**CAMECO RESOURCES
CROW BUTTE OPERATION**

June 23, 2022

Subject: Clarifying Questions

**2016 Core Holes
Outside Disturbed Area
Crow Butte License Area**

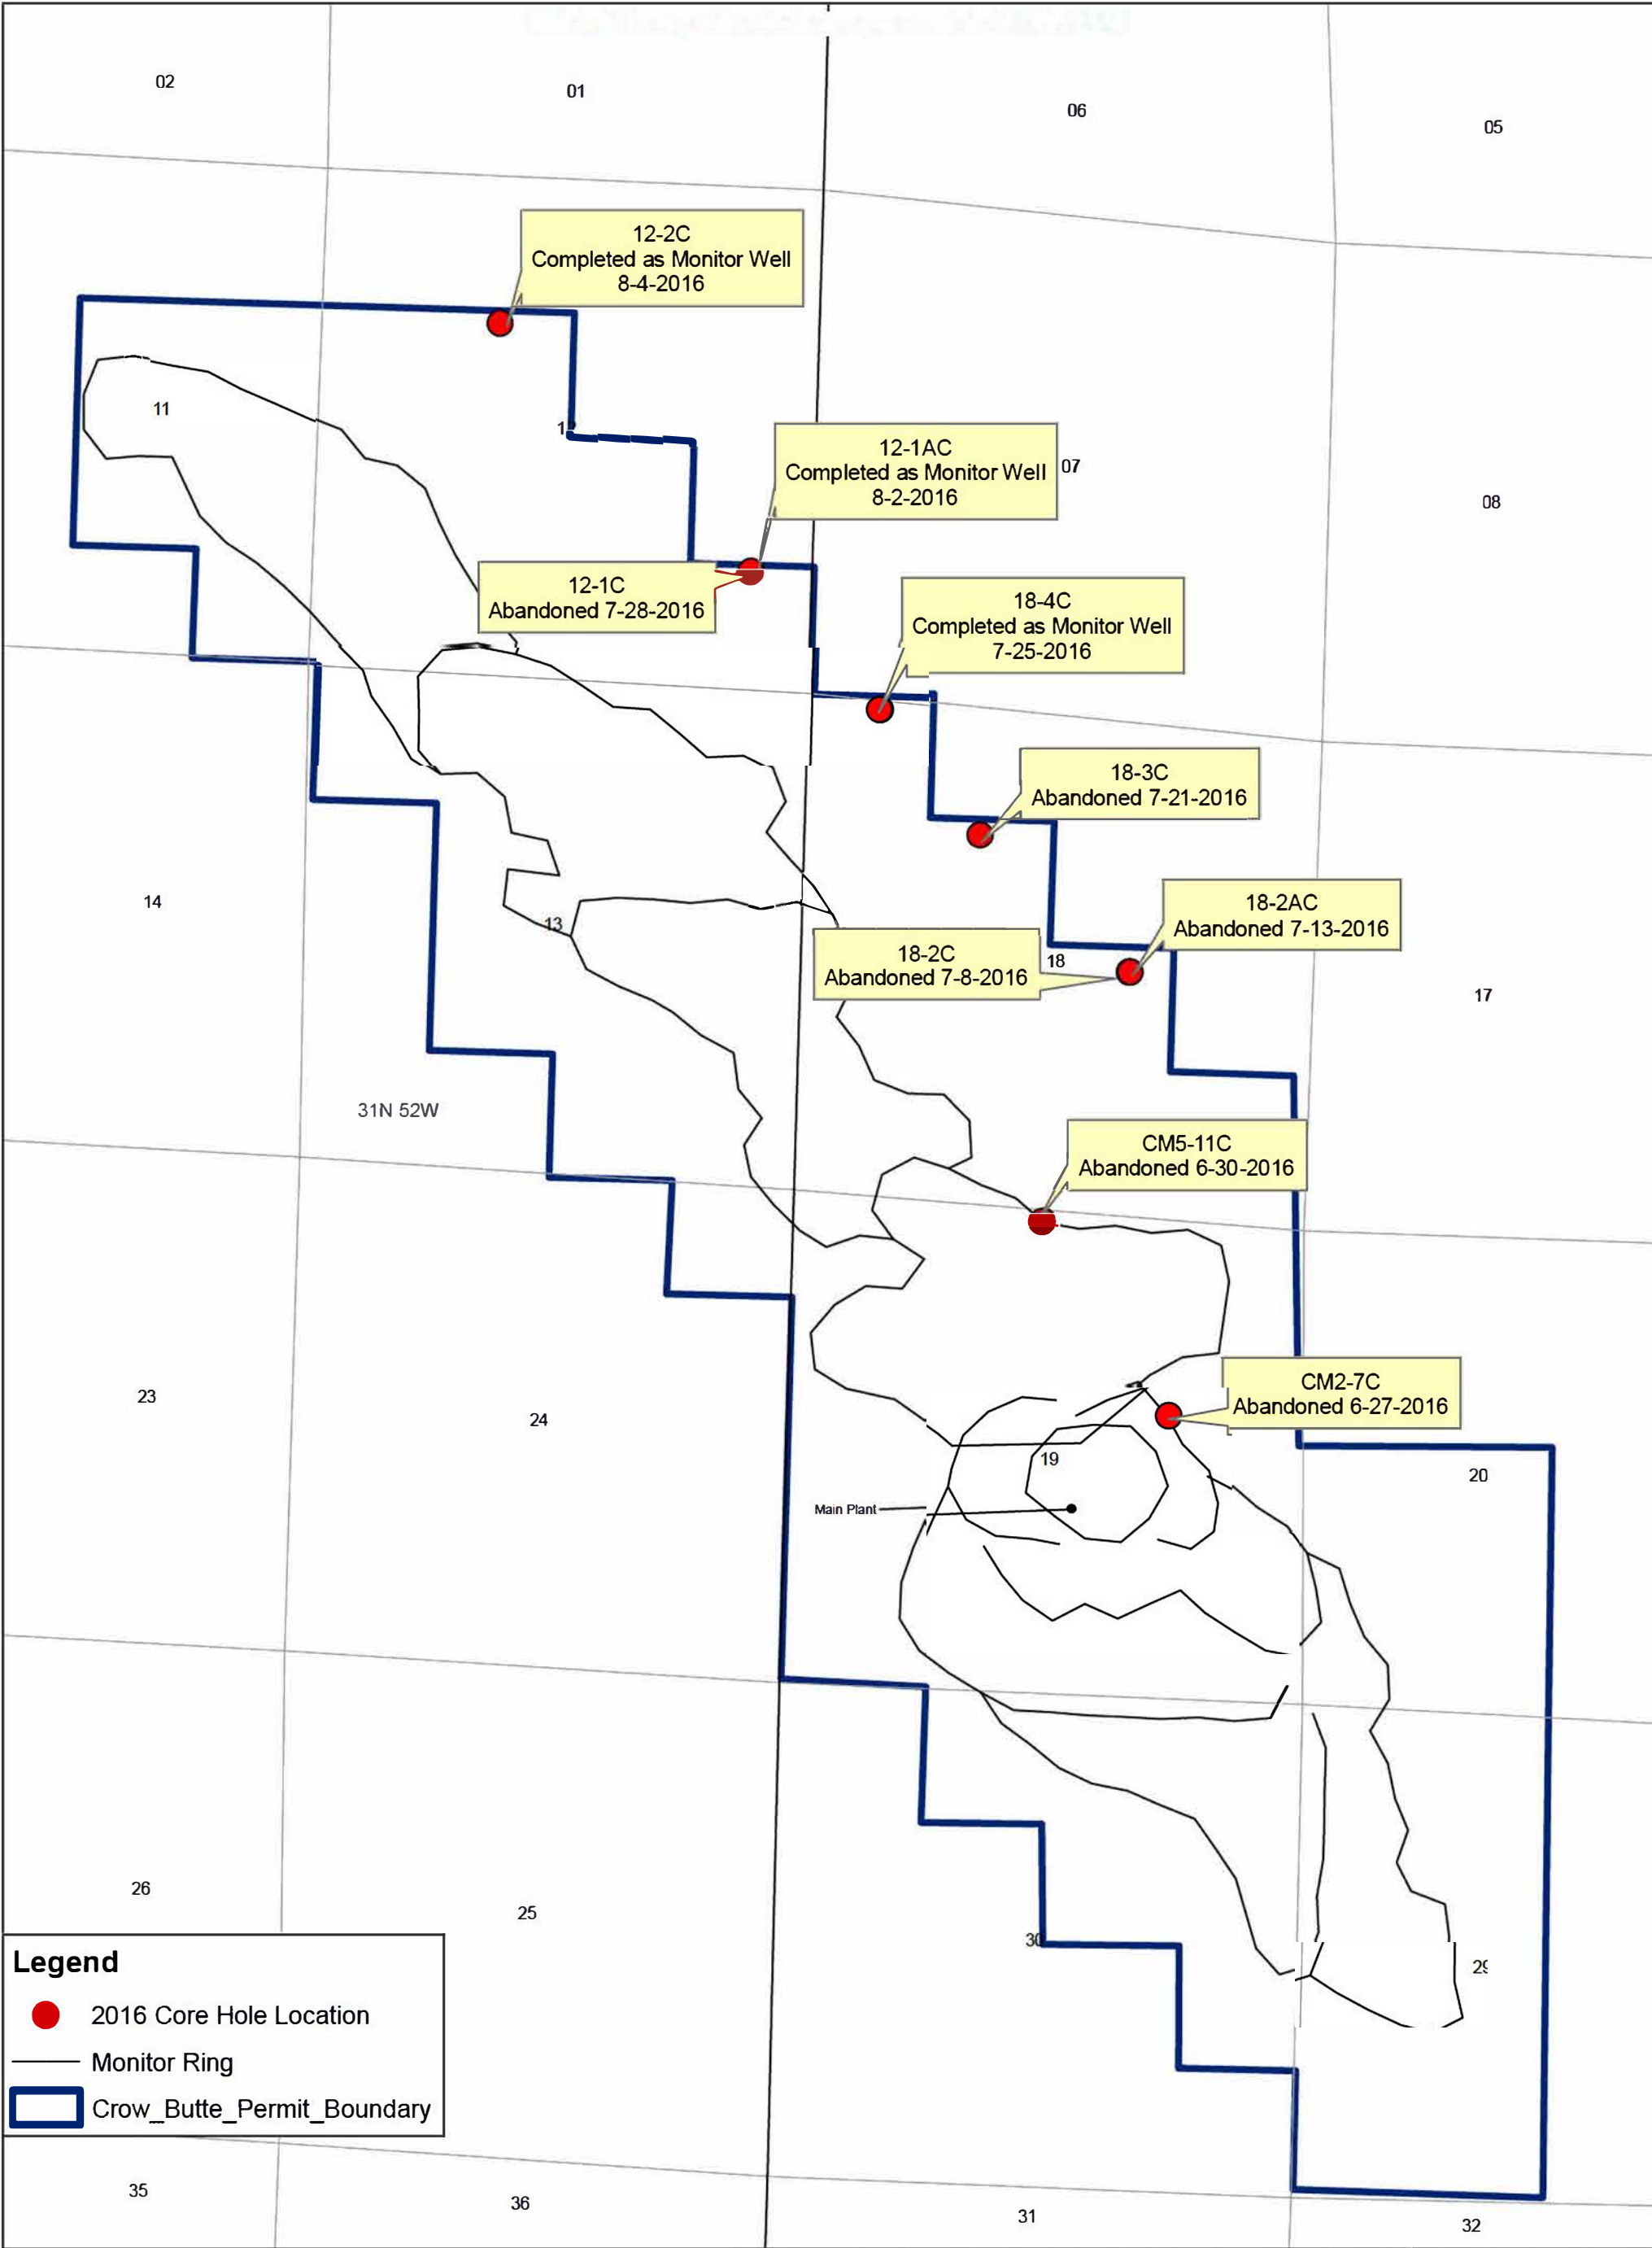
3. Have any new exploratory wells been drilled in the license area since the renewed license went into effect (i.e., since November 2014)? (If so, please provide a map showing where they are/were located.)

There have not been any true exploratory wells drilled since prior to November 2014. There have been nine wells drilled outside of the disturbed area since November 2014. The well locations and status are indicated on the attached map. These wells were drilled to collect core data for restoration purposes. Three of these wells were completed to be used as monitor wells during restoration. The remaining wells were plugged and abandoned.
